REGULATED ENTY NAME CEDAR CREEK WWTP

PERMIT NUMBER: WQ0016303001

Cedar Creek MH, LLC
TPDES PERMIT FOR MUNICIPAL WASTEWATER
PERMIT NO. WQ0016303001

RE: *Public Comments on Application by Cedar Creek MH, LLC ("Applicant" or "Cedar Creek MH"; Application for New Texas Pollutant Discharge Elimination System (TPDES) Permit No. WQ0016303001 ("Application")*

Dry Creek Segment 0404E

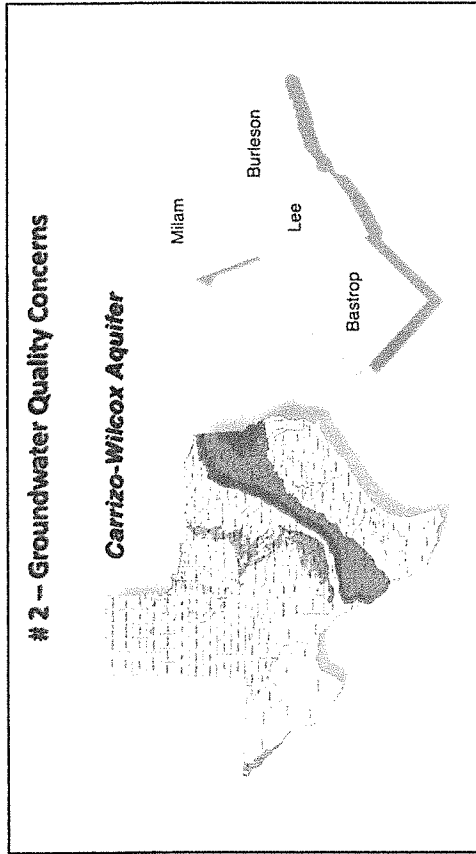
- 2022 Integrated Report – Texas 303(d) List (Category 5)
 - Bacteria in water (Recreation use)

- Exceptional Use [Aquatic Life, Contact Recreation, Fish Consumption, Public Water Supply]
- Most recent TCEQ *Water Quality Inventory* conducted 2002
 - Concerns listed:
 - Nitrite + Nitrate Nitrogen
 - Overall Nutrient Enrichment Concerns
 - Macrobenthos Community
 - Fish Community
 - Overall Narrative Criteria Concerns
- 20+ years of LCRA water quality sampling demonstrate “red flags” for these concerns
- 2/7/2024 TCEQ granted a contested case for permit WQ00113977001 regarding water quality concerns raised above.

11/20/2015 - AAS

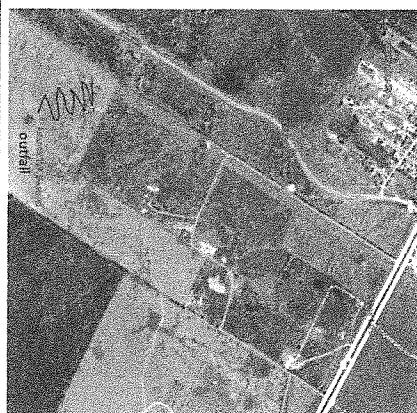
Application states the applicant will raise the WTP foundation by 10 feet because the WTP is located within the flood plain.

Thunderstorms produced heavy rain that caused flash flooding leading to high water rescues on Tucker Hill Ln. near the Bastrop and Travis County line. Damage assessment from Bastrop County indicated nearly 60 homes destroyed, with 40 also sustaining major damage. Overall, more than 100 homes were flooded or affected by the flooding many of them along Dry Creek near the Bastrop/Travis County line. Debris line showed that water was flowing over Highway 71 near this area. [Damages estimated at \$2.1 million]

Groundwater & Surface Water Quality

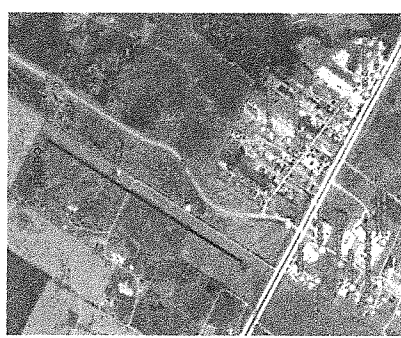
- If regionalization is not feasible, move the outfall for Cedar Creek MH WTP to the southern end of the property and use existing ponds/wetlands to enhance integration of treated effluent before it enters Dry Creek and/or Colorado River.
- Increases run-of-creek by two miles [8.5 vs 6.5 miles]
